Moorebank Precinct West - Concept Modification

Response to Submissions - SSD 5066 MOD1

Author	Ben Fethers, Alexandra Hopkins, Laura Hoffman, Sam Withers	
Checker	Westley Owers	
Approver	Bradley Searle	
Report No	Final	
Date	5/12/2016	
Revision Text	Final

Figure 6-1 - MPW site layout (concept)

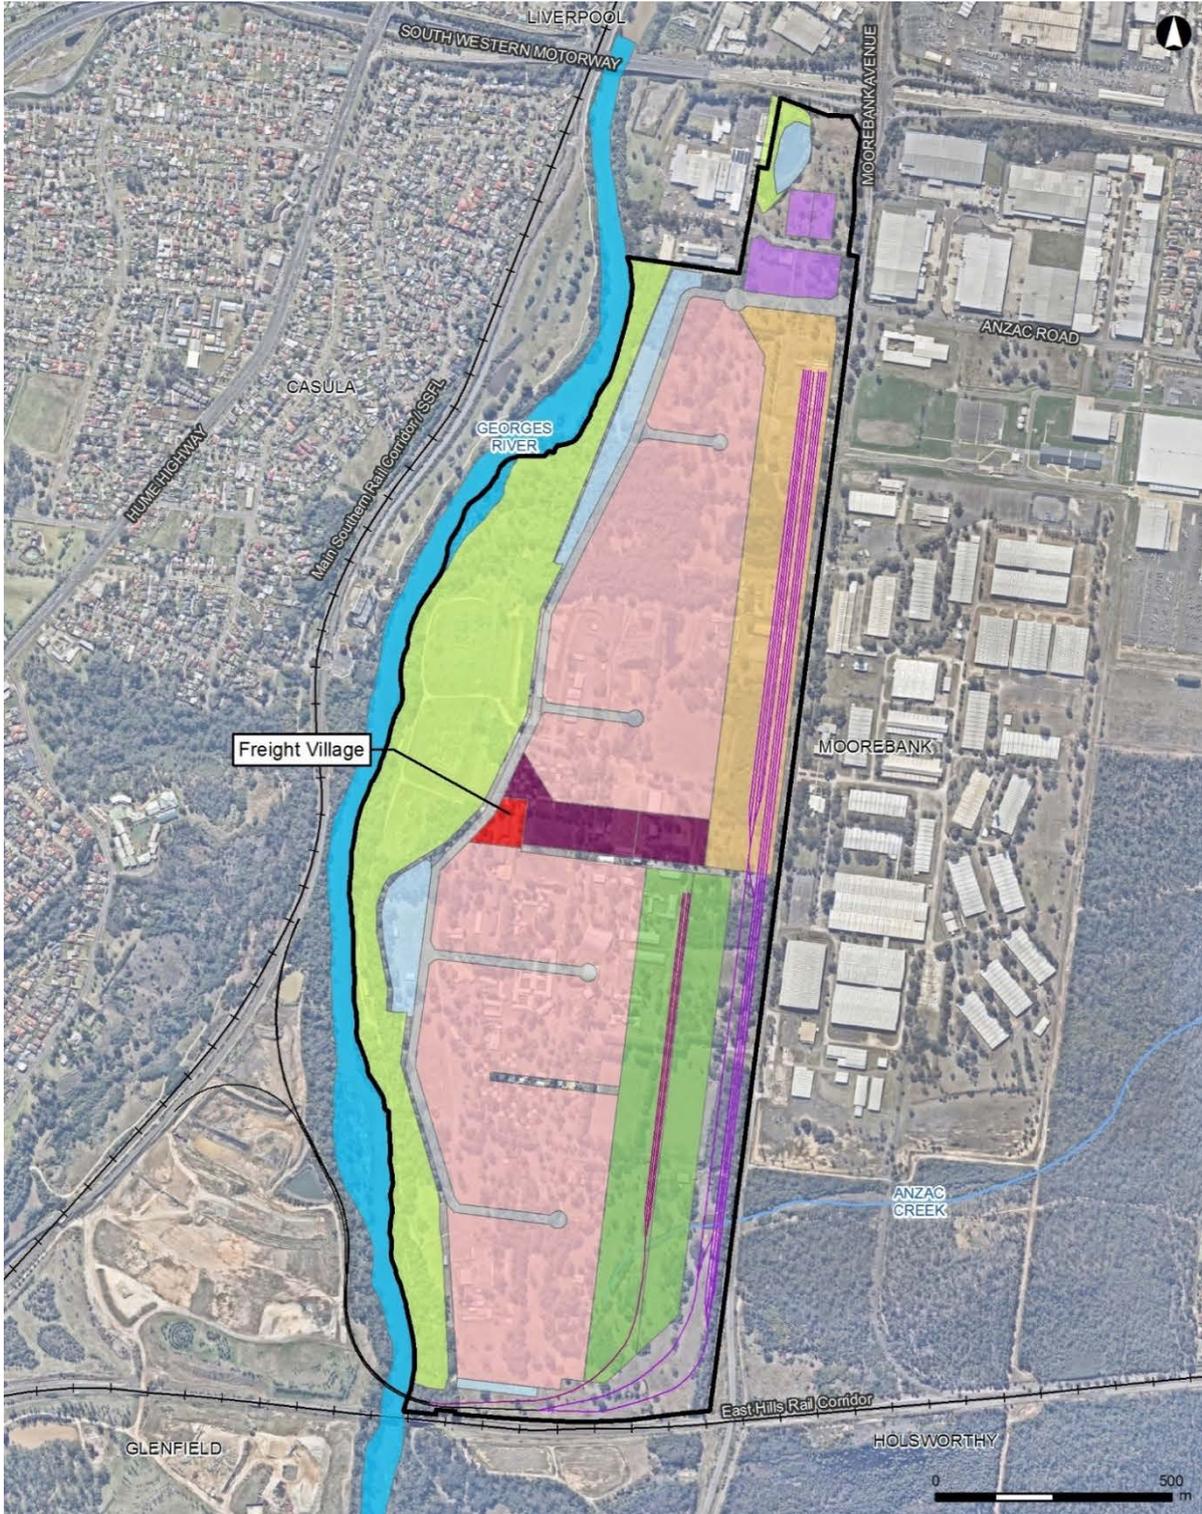
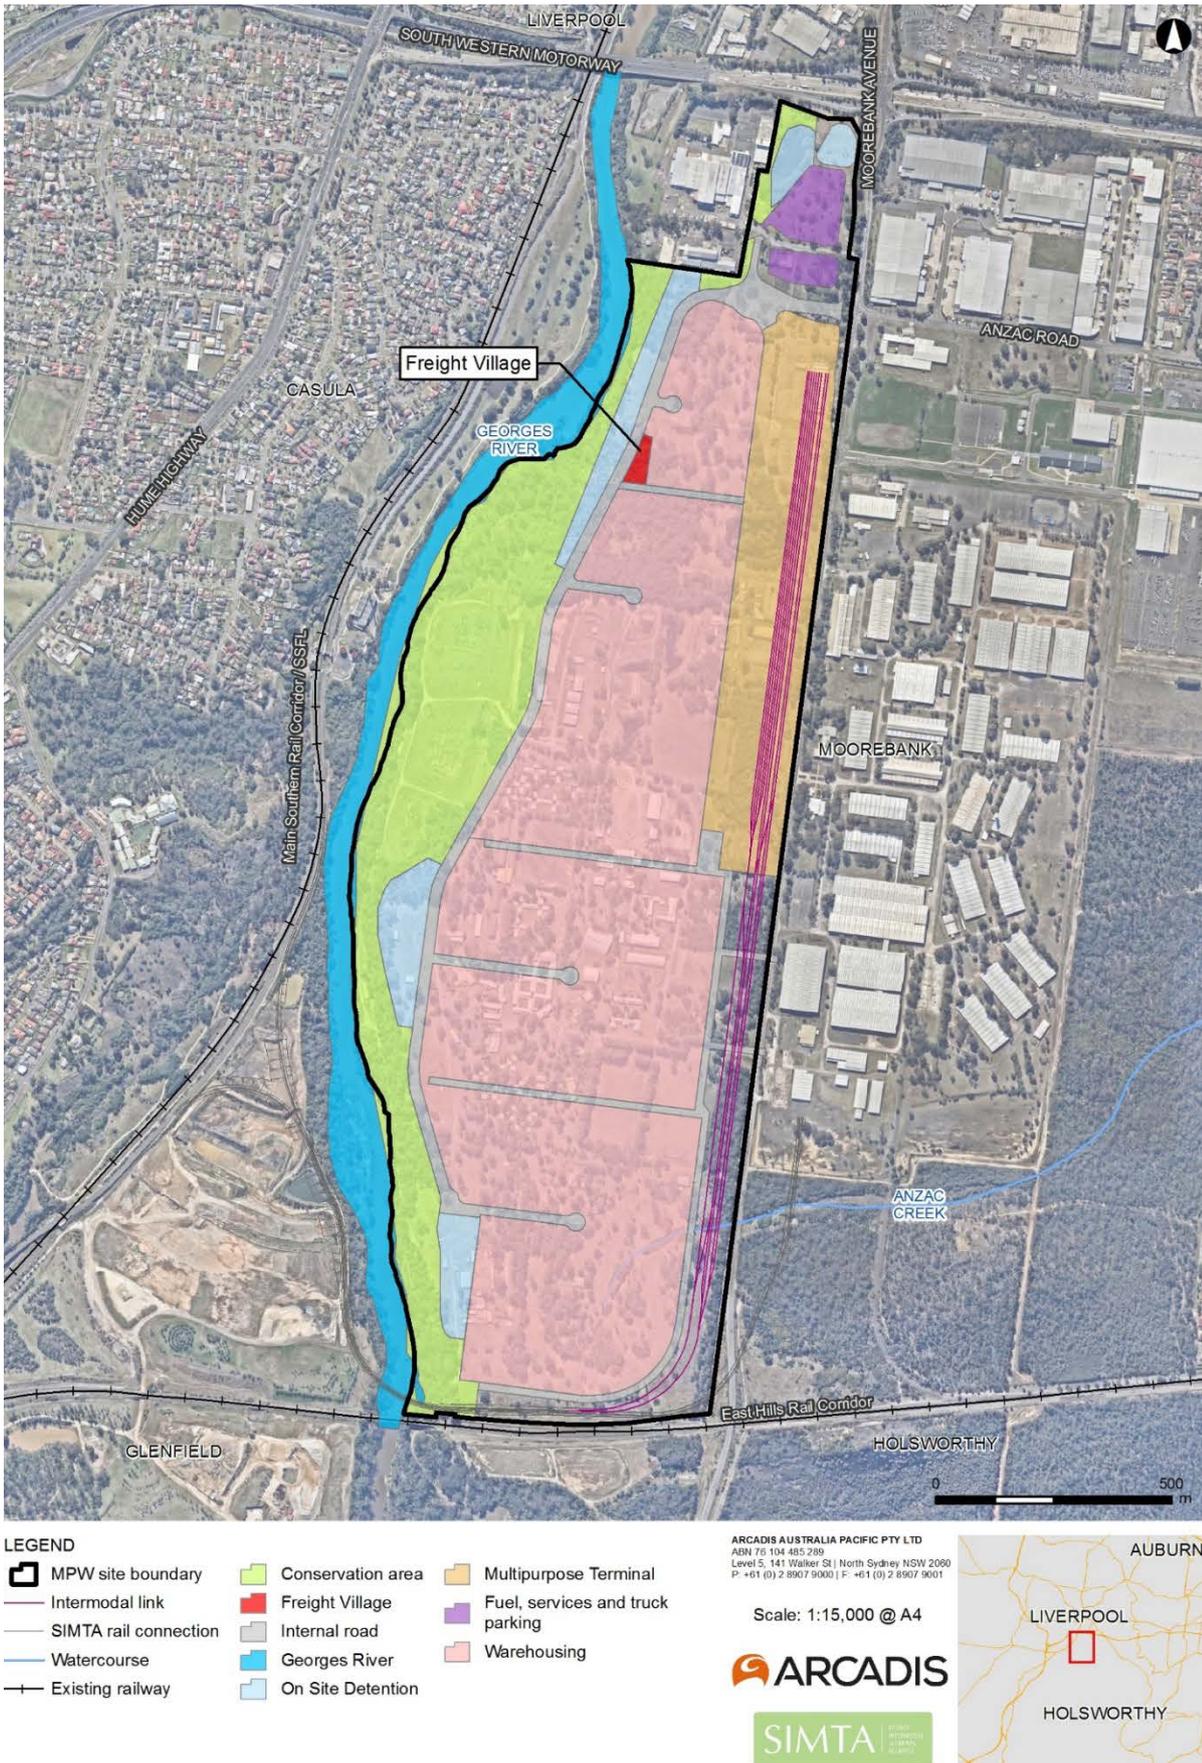
Figure 6-1 and Figure 6-2 illustrates the key re-arrangement in location of land functions, which are further explained below.

The freight village for the Amended Modification Proposal has been relocated to an area previously identified for warehousing, at the northern end of the MPW site, directly adjacent to the drainage channel (that leads to the northern OSD) and western perimeter road (refer to Figure 6-2). The land previously identified for the freight village is identified for warehousing under the modified layout.
